ADDENDUM NO: ONE

REFERENCE: IFB No: 2021-088-IFB-04223
Commodity: Albemarle County Office Building McIntire Window Replacement
IFB Closing On: April 22, 2021

ALBEMARLE COUNTY OFFICE BUILDING MCINTIRE - WINDOW REPLACEMENT
CHARLOTTESVILLE, VIRGINIA
County Project No: 2021-088-IFB-04223
Architect's Project No: 593752

ACM 3

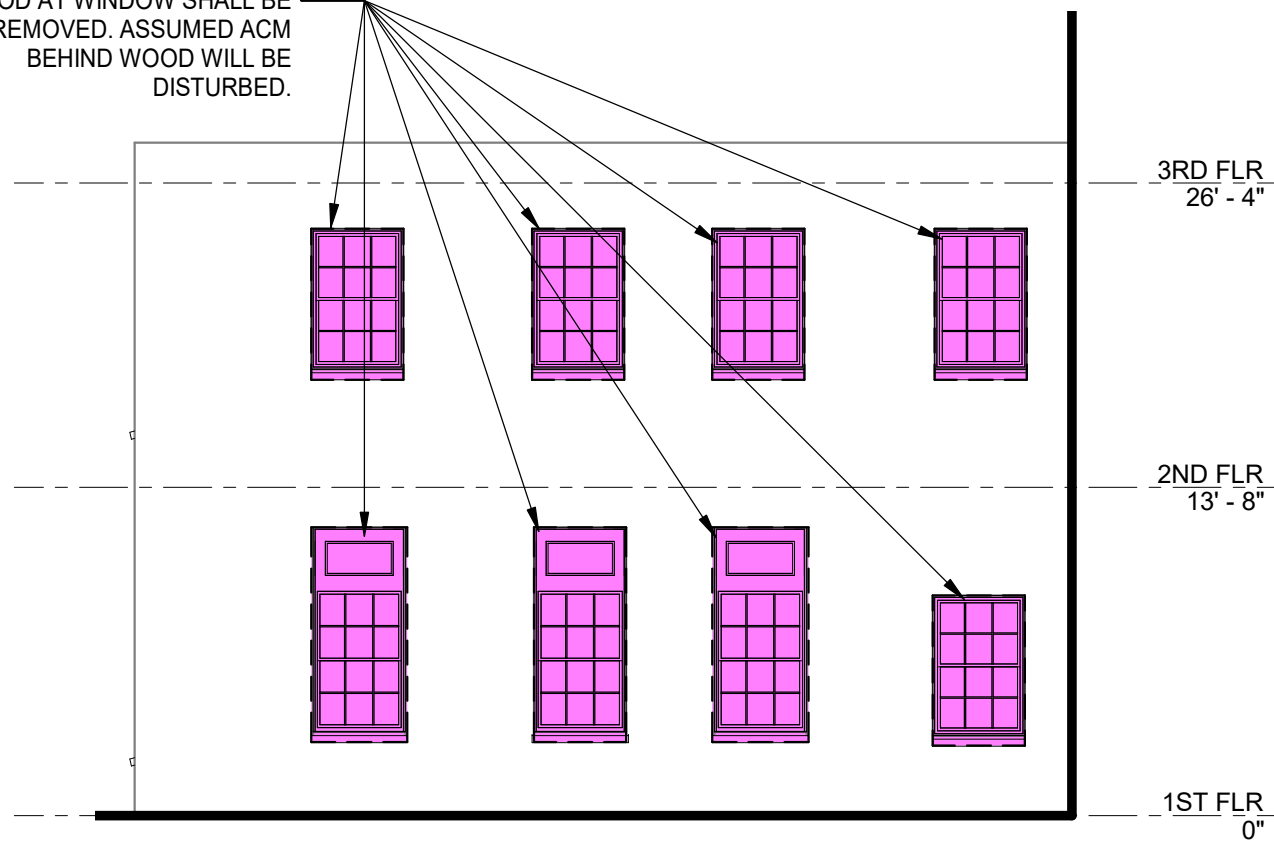
WOOD AT WINDOW SHALL BE REMOVED. ASSUMED ACM BEHIND WOOD WILL BE DISTURBED.

ACM 4

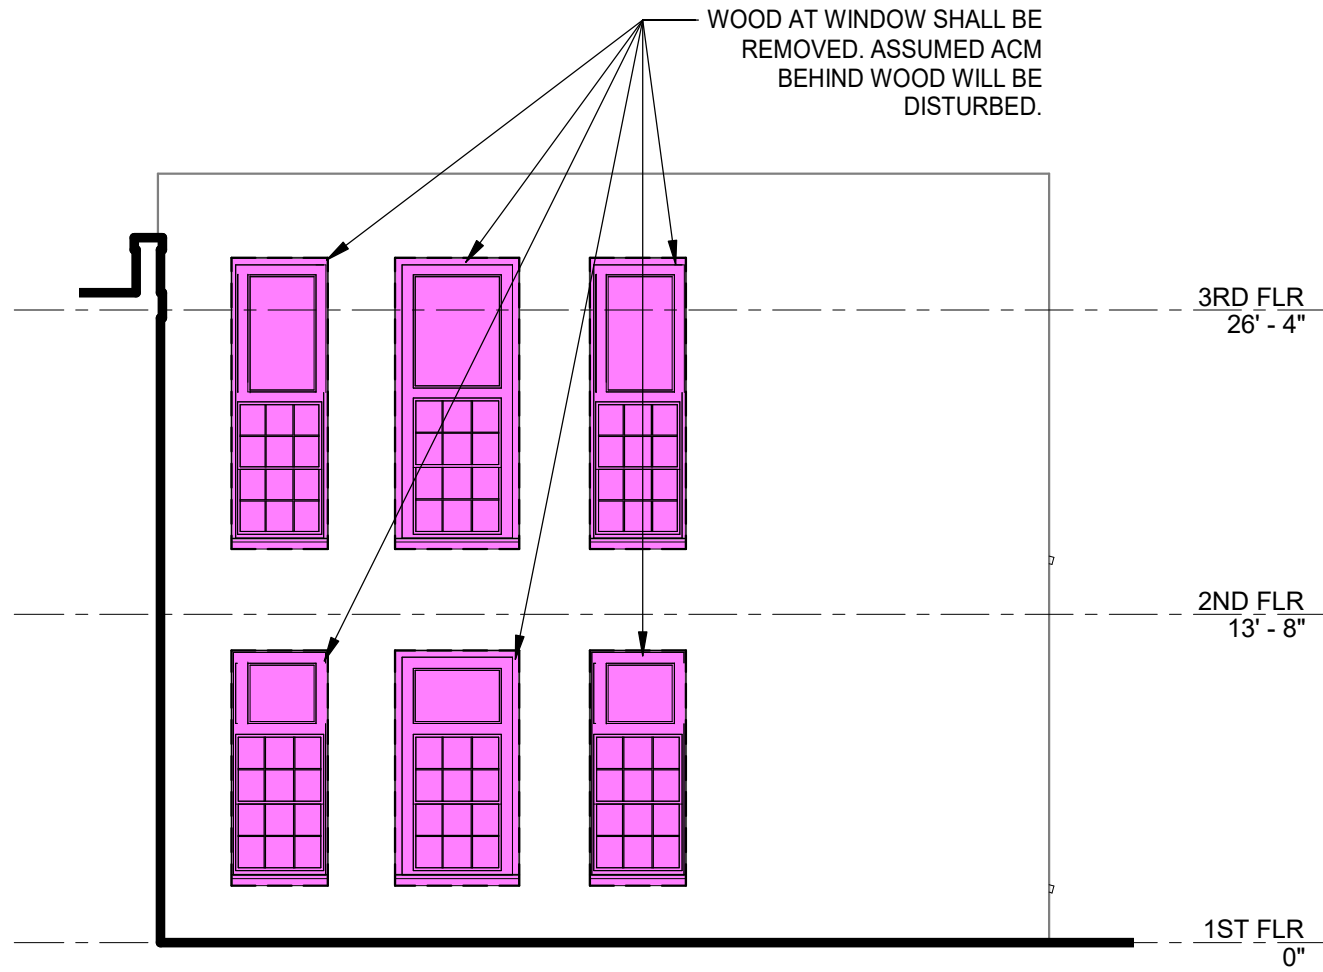
WOOD AT WINDOW SHALL BE REMOVED. ASSUMED ACM BEHIND WOOD WILL BE DISTURBED.
